Product Change Notification

Change Notification #: 116708 - 00
Change Title: Intel® Server System R2308WTTYSR, PCN 116708-00, Product Design, Label, Outer box label stacking logo update, Hot-Swap Back Plane Firmware Update,
Date of Publication: January 14, 2019

The Image below shows an example of the label logo P/N update.

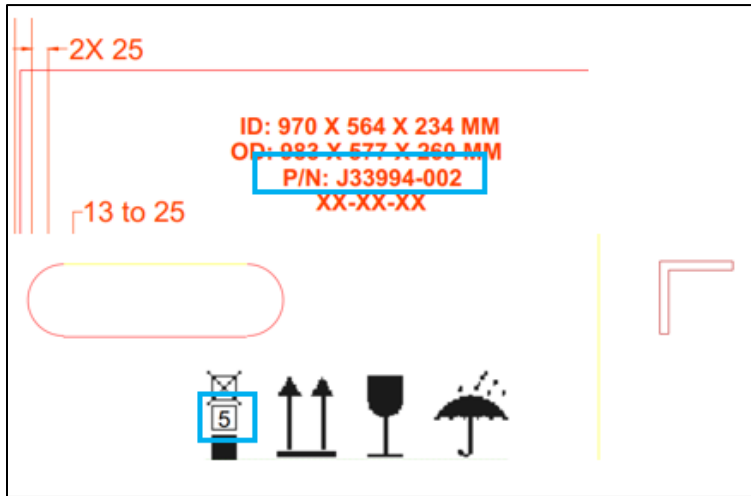
1. Updated the outer box label logo.

The previous logo means that the maximum layers supported in a pallet are 7 in total, however only 6 layers as maximum can be supported. The P/N (Product Number) of the label is being updated for listed products as follow.

- I. Intel Server 1U Systems and 1U Chassis updates the P/N from J34109-001 to J34109-002.
- II. Intel Server 2U Systems and 2U Chassis updates the P/N from J34107-001 to J34107-002.
